**COMMENT RESPONSES/REVISIONS TO THE OHIO ENVIRONMENTAL PROTECTION AGENCY JUNE 12, 1998, COMMENTS ON THE DRAFT IMPLEMENTATION PLAN FOR ABOVE-GRADE DECONTAMINATION AND DISMANTLEMENT OF THE SEWAGE TREATMENT PLANT COMPLEX**

DOE RESPONSES TO  
OHIO EPA COMMENTS DATED JUNE 12, 1998  
ON DOE RESPONSES/REVISIONS TO THE  
DRAFT SEWAGE TREATMENT PLANT COMPLEX IMPLEMENTATION PLAN

**PROPOSED REVISIONS TO THE STP COMPLEX D&D IMPLEMENTATION PLAN  
(TEXT SHOWN IN REDLINE/STRIKEOUT FORM)**

FIGURE 1-1 Sewage Treatment Plant Complex Project Area

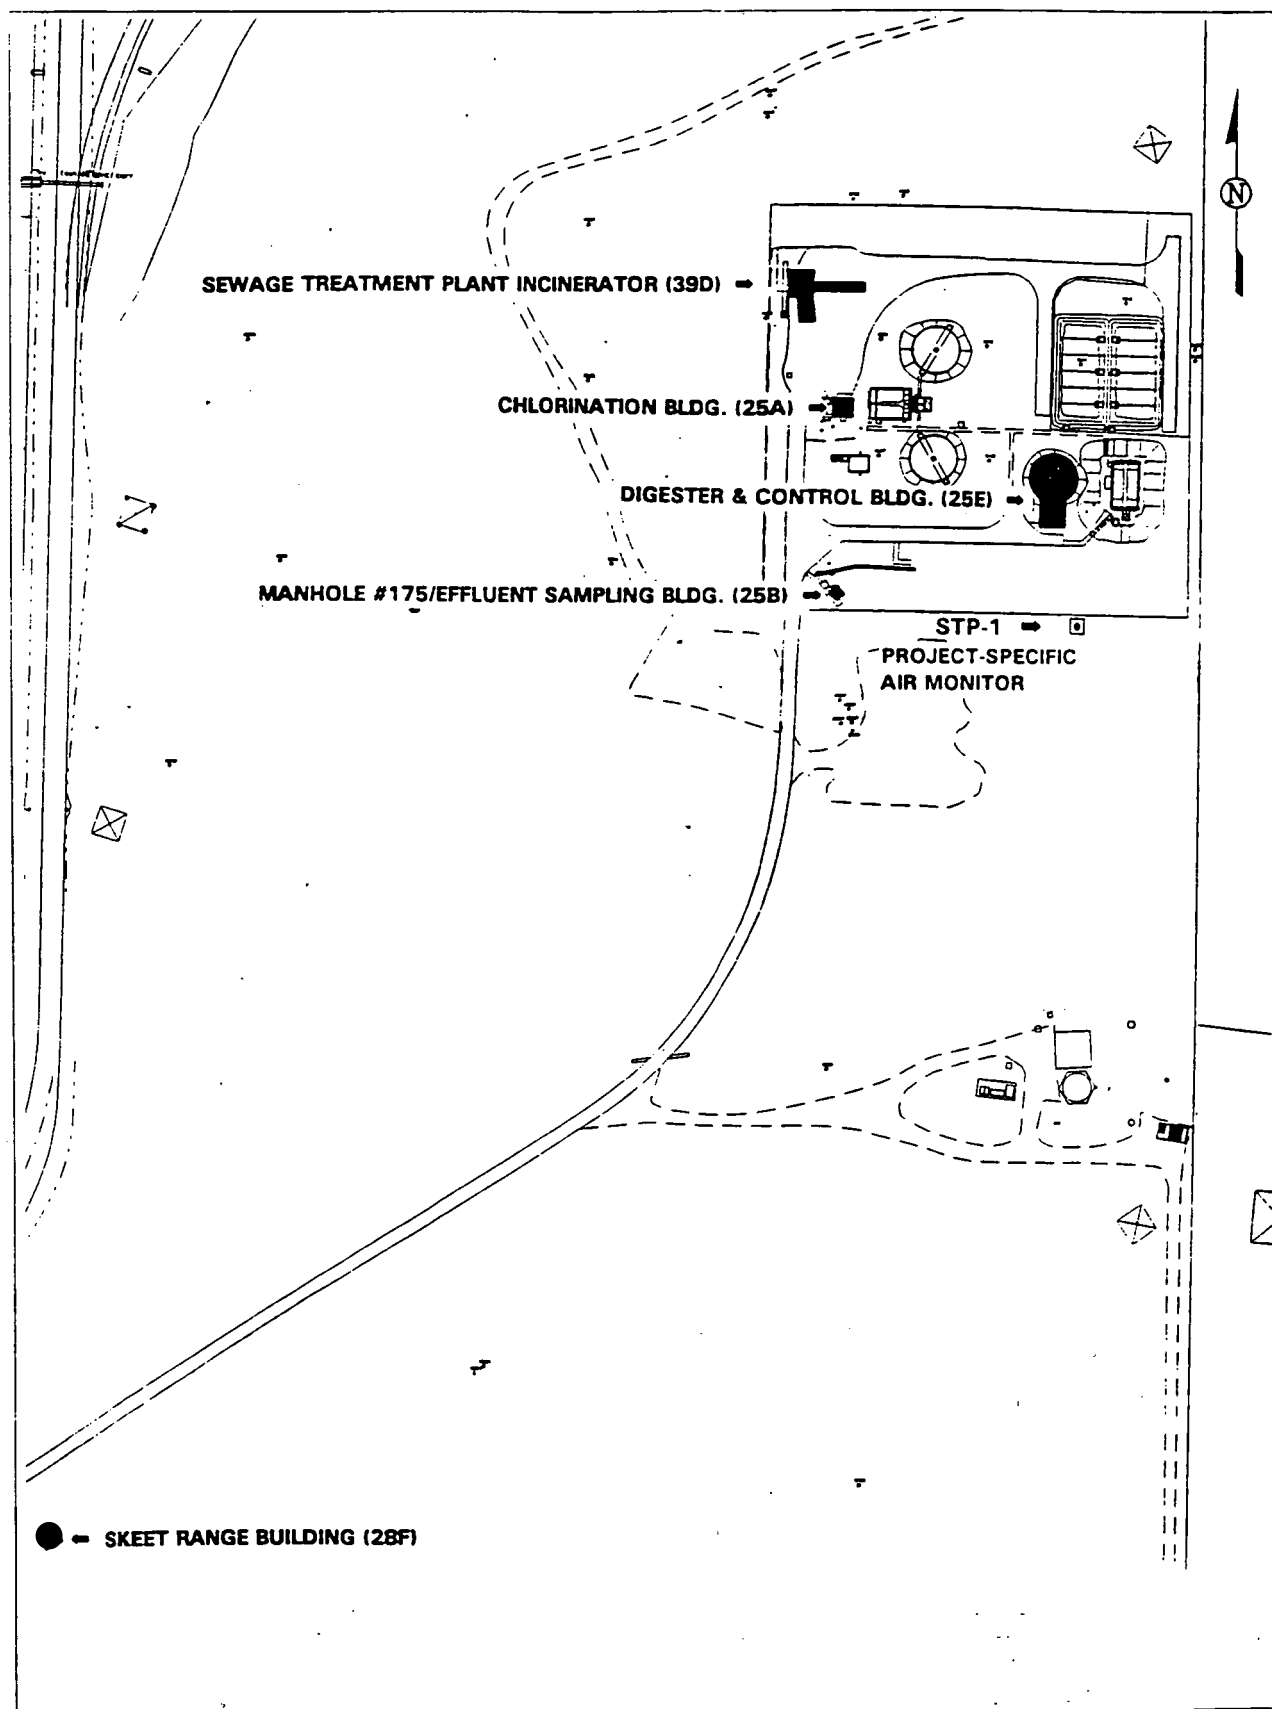
*[Original Comment 5] It is interesting to note that since Ohio EPA made the original comment recommending project specific air monitoring, DOE's dose estimates have gone up over 3 orders of magnitude. Yet, DOE still proposes no monitoring at the MEI. Considering this is likely to be the most contaminated remediation at the property fence line, DOE's decision is dismaying. Ohio EPA expected that DOE would want to collect data at the MEI to demonstrate to the public the effectiveness of control activities. Ohio EPA reiterates our recommendation that DOE conduct project specific air monitoring at the MEI.*

Section 2.4 of the Implementation Plan has been revised to reflect the detail described above. Figure 2-1 was revised to include the location of air monitor STP-1 among the IEMP air monitors. Figure 1-1 also has been revised to illustrate the location of the supplemental monitor relative to the project area. Text changes were made in redline/strikeout form on pages 16 (line 28), 17 (lines 1-3), 19 (lines 2-12, and 24-26), 21 (lines 26-31), 22 (lines 1 and 4-6).

FIGURE 2-1 FEMP Site and STP Complex Air Monitoring Locations

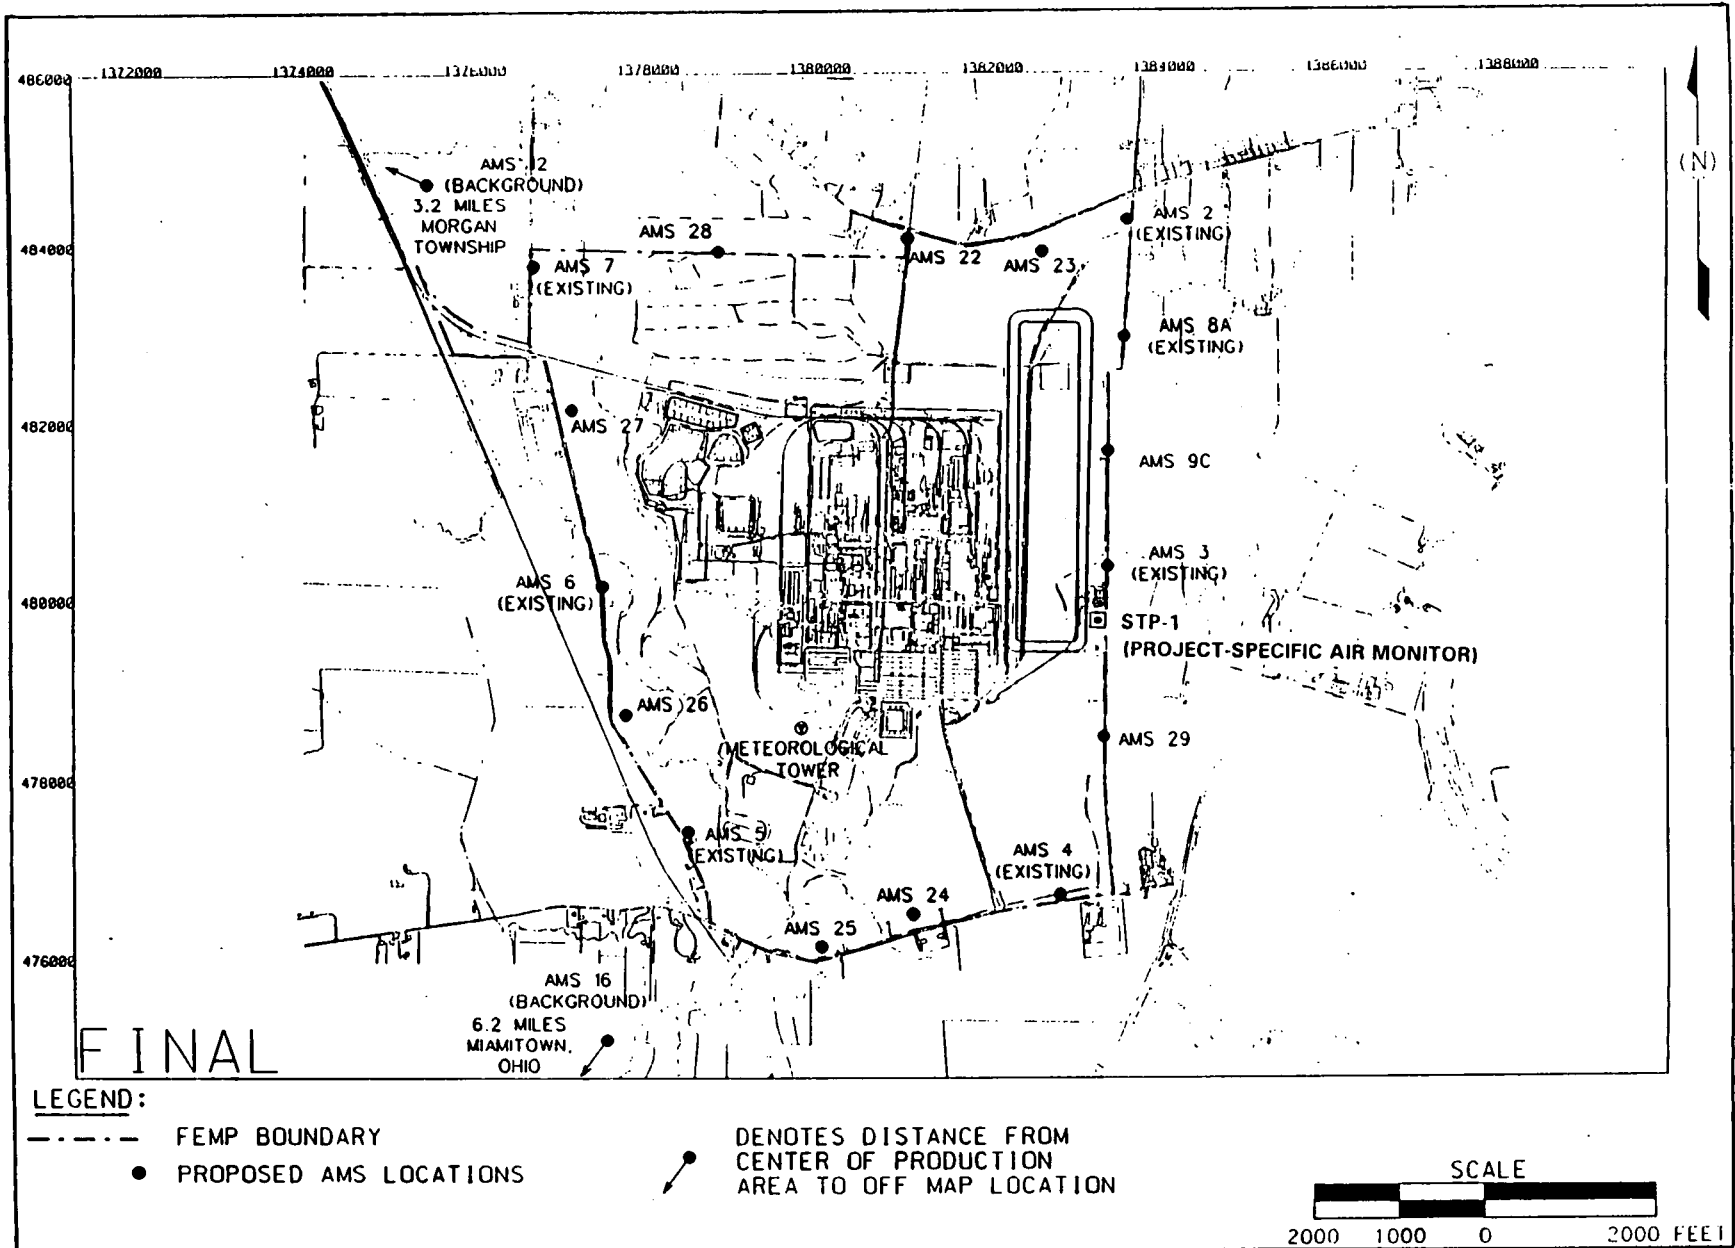
- Although the original decision not to conduct supplemental radiological air monitoring at the maximally exposed individual (MEI) was based on the correct dose estimate (i.e.,  $1.3 \times 10^{-3}$  mrem/year), DOE has agreed to provide a continuous air monitor in a spot located in the southeast quadrant of the STP project area in line with the MEI. Placement of the project-specific air monitor at the MEI is not possible due to the consistent opposition by off-site residents in the past when FEMP air monitors were proposed to be placed on their properties. Considering the proximity of the proposed monitoring location to the D&D activities, it will provide adequate monitoring capabilities for potential migration of contaminants toward the MEI.

- The decision to provide this one supplemental monitor (designated as STP-1) for the STP D&D project is in recognition that since the STP is located immediately adjacent to the fenceline, existing FEMP monitors may not provide optimal coverage. Accordingly, the location of the supplemental monitor in the southeast quadrant of the STP project area was
